# Lifting point deemed unfit for use?

## We have a solution.

### MPLATE F&B'S

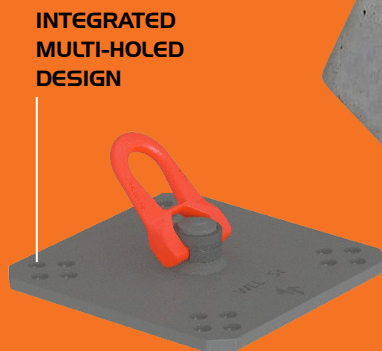
The updated design of the mistake plate, consisting of a swivelling head, allows the plate to be loaded in any direction with no impact on its 5t WLL capacity. The new plate also has integrated multi-holed design in each corner, allowing for the user to drill new holes if reinforcement is hit, without having to reposition the plate.

- 5t WLL
- *NEW* swiveling head allows for loads to be applied in any direction with no reduction in capacity
- Suitable for thicknesses of 150mm and above
- Compliant to AS3850:2015 (+AI 2019) & NZ GPG 2018
- Made in Australia
